# Historic Preservation Commission

January 28, 2021

# 1636 2<sup>nd</sup> Avenue SE – Garage Demolition

# Garage Photos

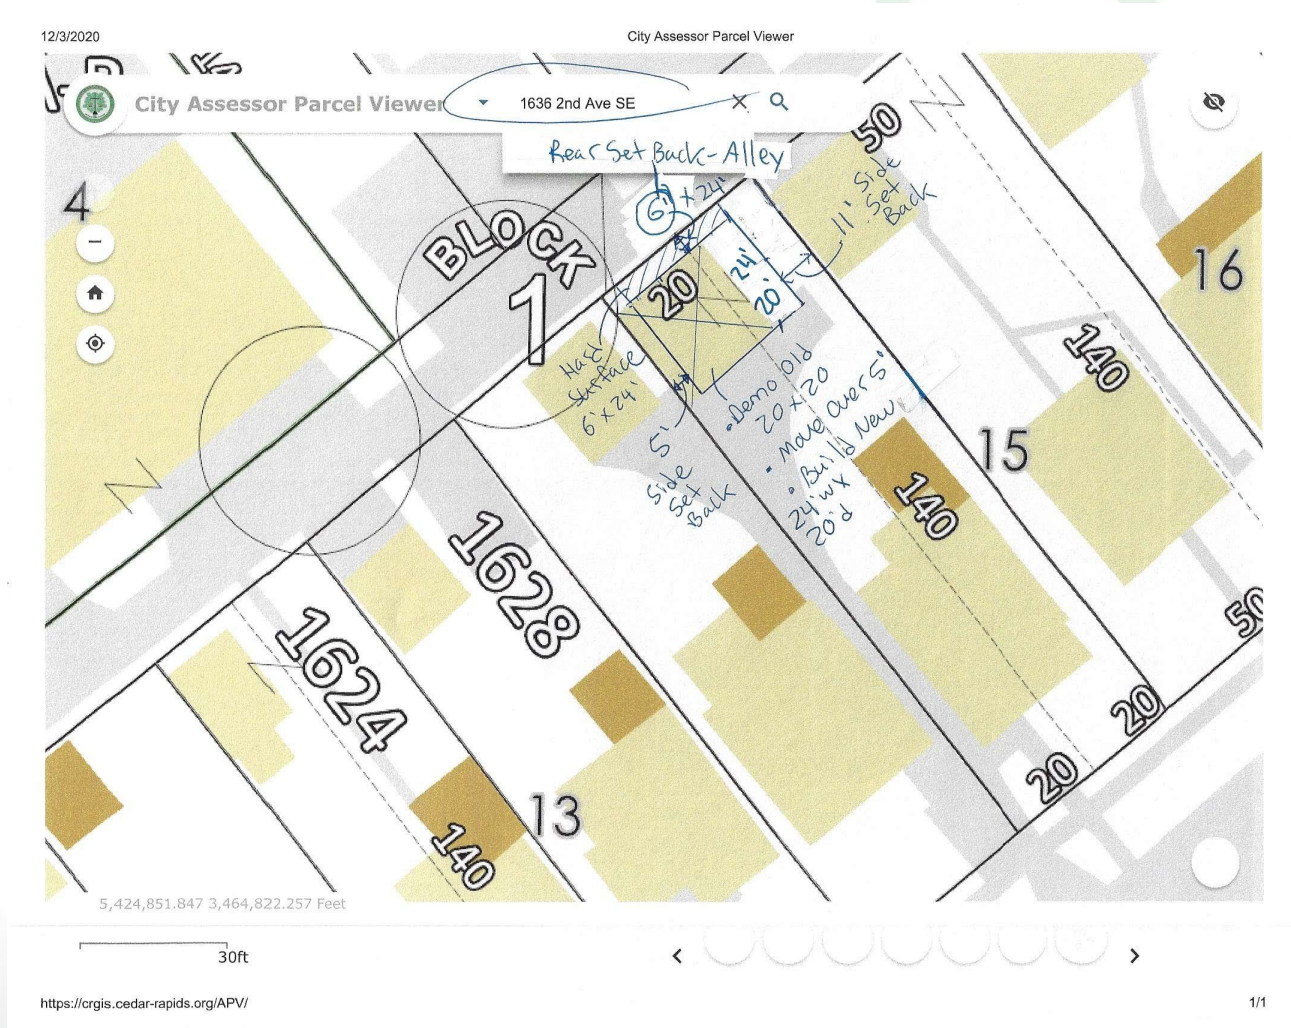
- Staff recommends approving the Certificate of Appropriateness as the garage was damaged due to the August 2020 storm.

# 1636 2<sup>nd</sup> Avenue New Garage

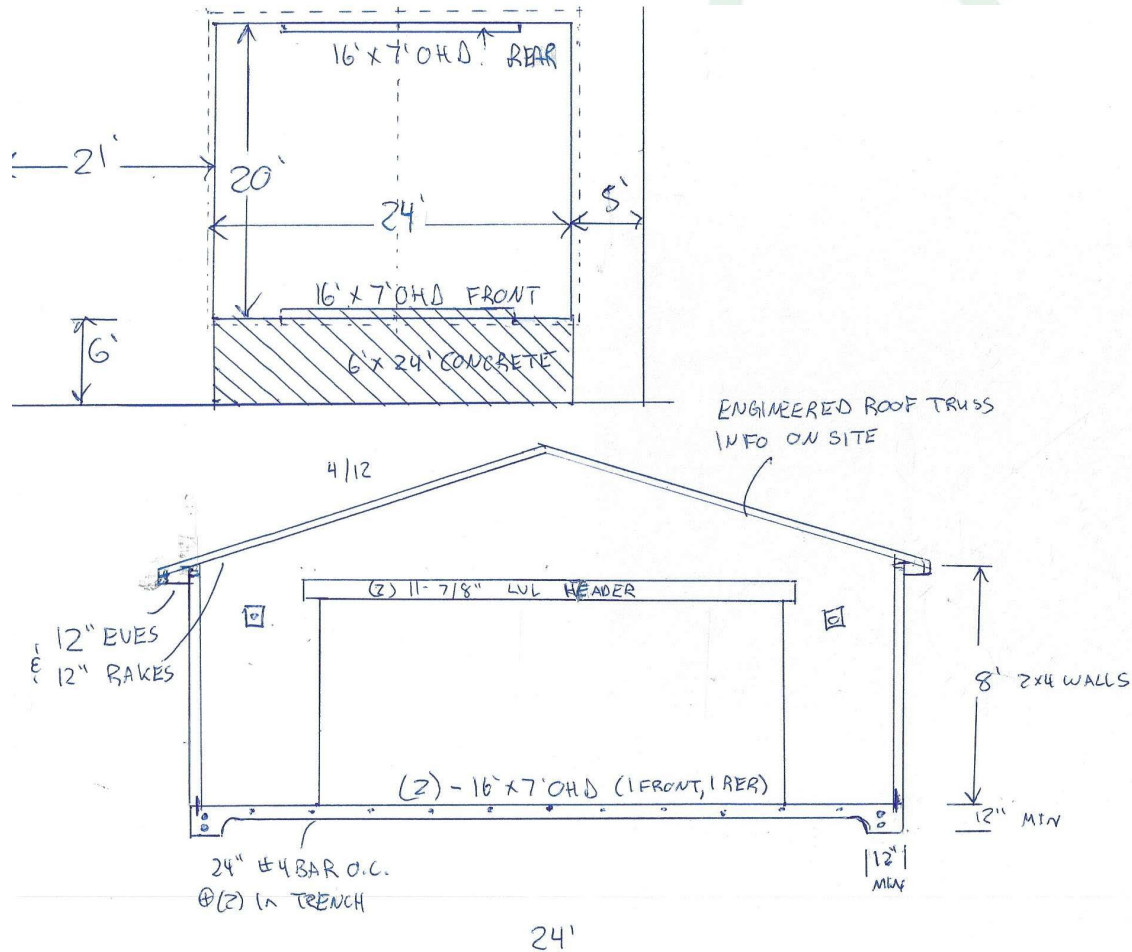
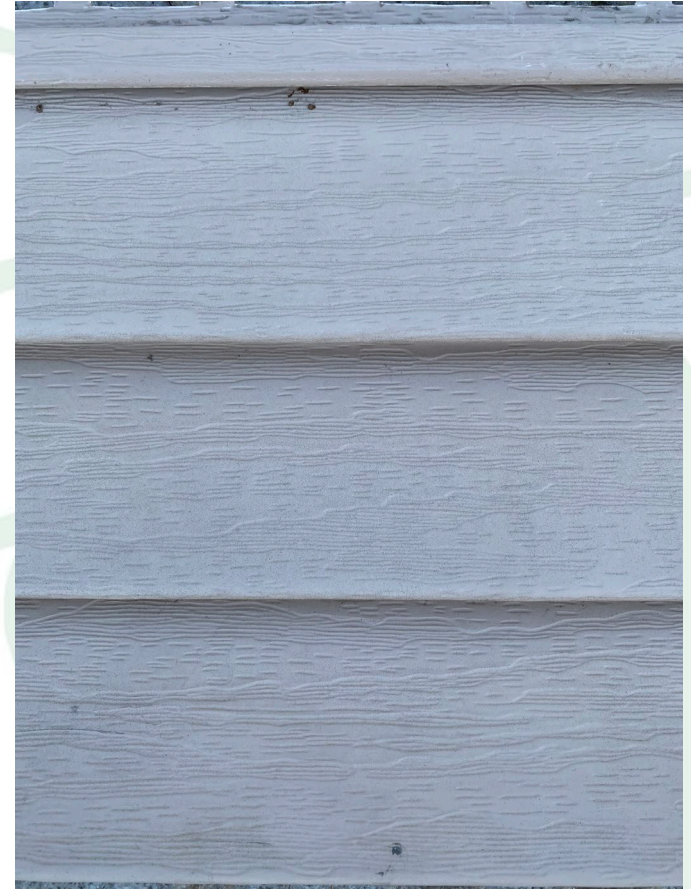
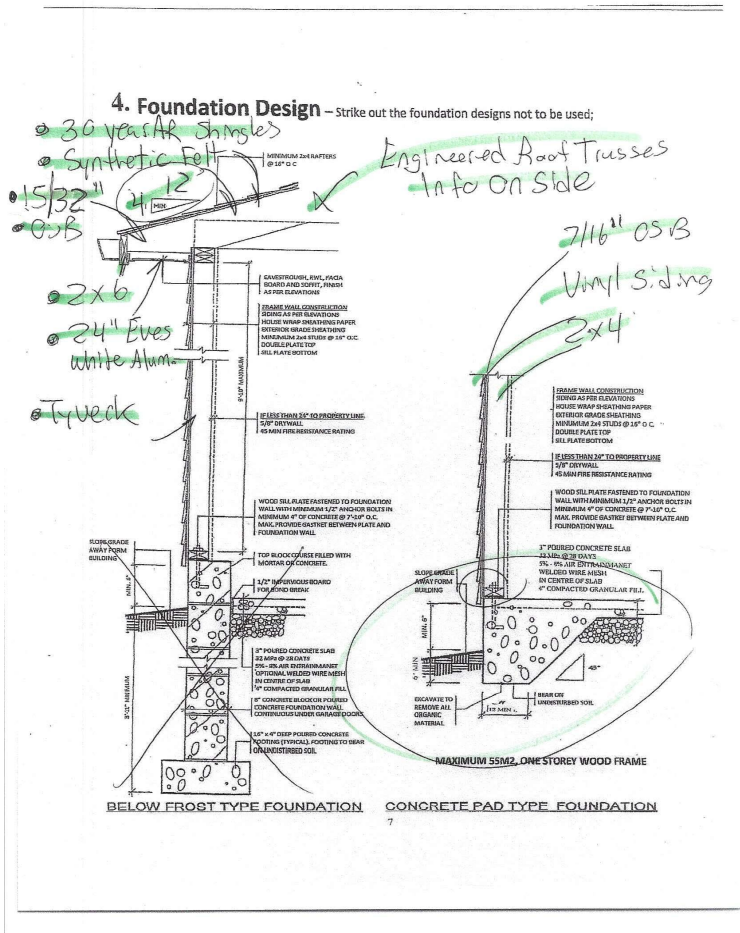
- Staff recommends approving the Certificate of Appropriateness to construct the new garage and the use of vinyl siding as both the existing house and original garage had vinyl siding.
